CORRIGENDUM

Sub: Extension of due date and Corrigendum - Regarding

Clarifications sought against tender No. 57(51)2020-PUR/T-45 dated 09/02/2021
for supply of Geophone and Digital Cable

Fig 1. Digital interface cable end connector & wiring details

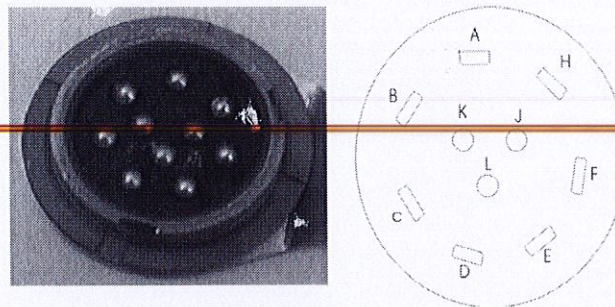
Point No1: Connector of Cable of both end need clarification with photo's / drawings. The color mentioned can be change?

Point No 2: Connector of Cable of both end need clarification with photo's / drawings. The color mentioned can be change?

The supplied digital interface cable will be used to interconnect two Geodes and the end connector should be mating with 24-Channel Geode supplied by Geometrics, USA. The cable should be tinned copper and twisted pairs to reduce the noise and make firm contact. The connector, pin & wiring details as shown in below Figure 1. If yellow colour outer jacket is not available, any colour is acceptable to us. Weight of cable is not compulsion, but ruggedness of cable is more important.

Fig 2 Seismic cable end conector

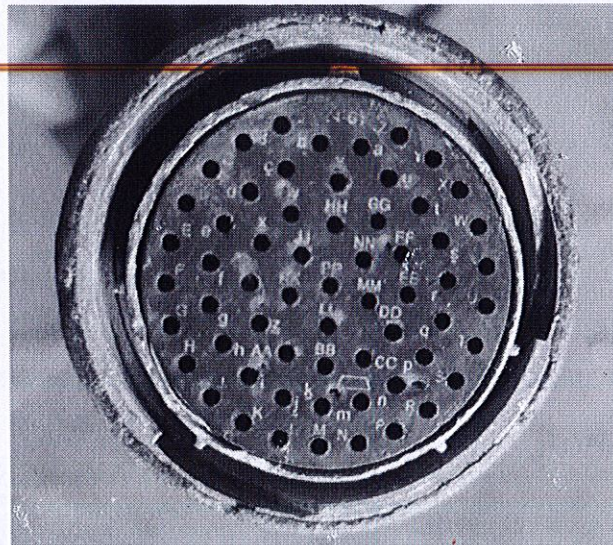
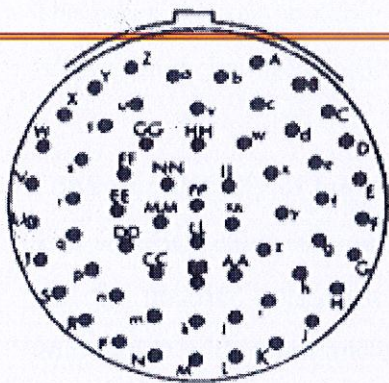
Point No. 3: Connector of Cable of both end need clarification with photo's / drawings.
Provide the Seismograph connector Drawing/Pin layout diagram.

Point No 4: Connector of Cable of both end need clarification with photo's / drawings.
Provide the Seismograph Connector Drawing/Pin layout diagram

The 24 channel Geode uses 61-pin Bendix male connector. The supplied seismic spread cable end connector should have compatible female connector and it should be firm contact with the Geode (Figure 2). Weight of cable is not compulsion, but ruggedness of cable is more important.

Fig 4. 4.5 Hz geophone with crocodile connectors

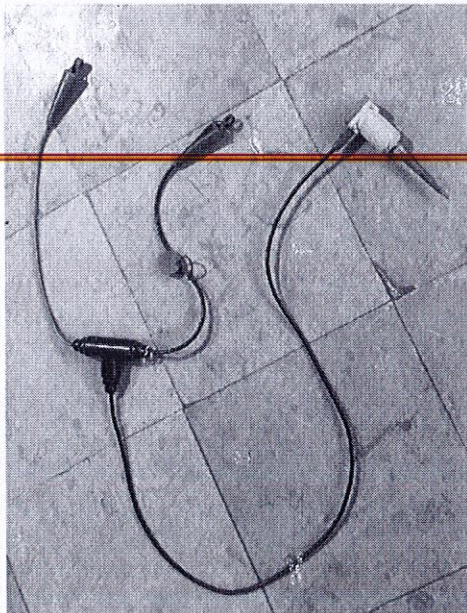
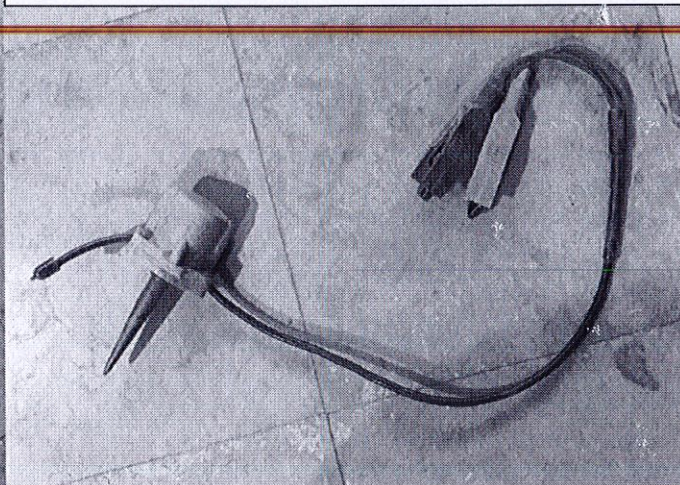
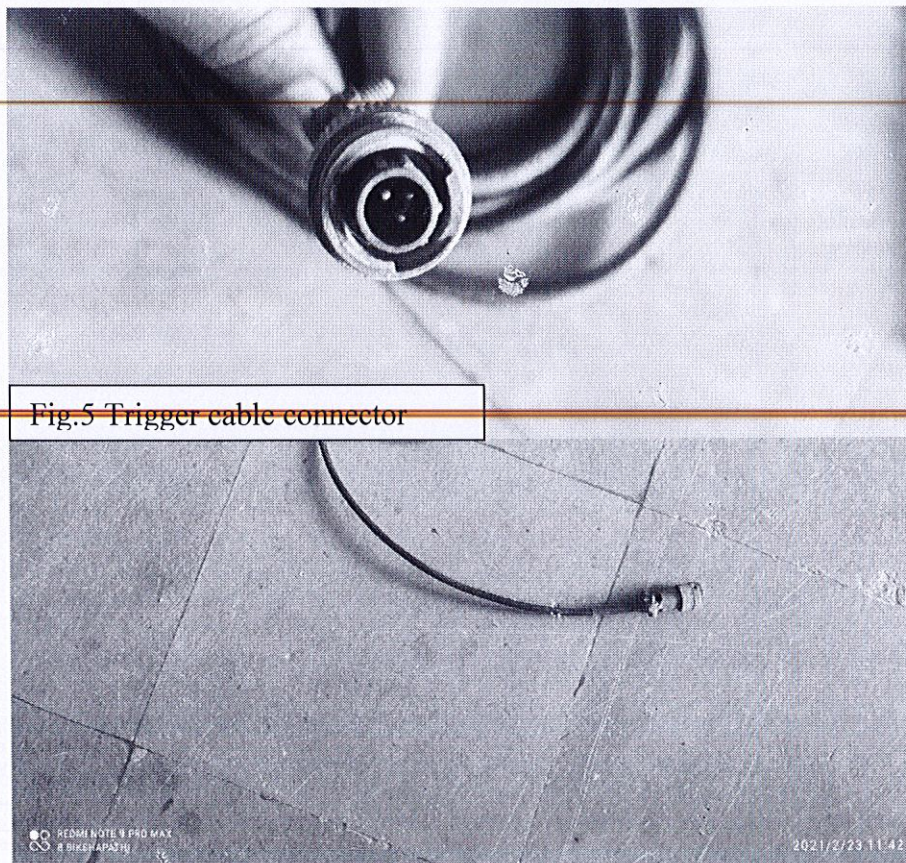
Point No 5: 4.5 Hz Geophone clean response to 160 Hz, 0.6 Hz, 0.6 V/m/sec sensitivity : provide details about the point no 5. what you require 4.5 Geophone ? it is single geophone ? what type of connector ? what is length of connector cable? is it vertical geophone with spike ? or it is only a geophone sensor element with shunt install on it ? kindly provide the photo of this requirement to better understand the requirement.

It is vertical single spike 4.5Hz Geophone output connector is a crocodile clips (big) in size with red and black color indication also 0.5m cable length. Further, it should have proper external casing with vertical spike for good ground coupling etc. also it should withstand in harsh environments.
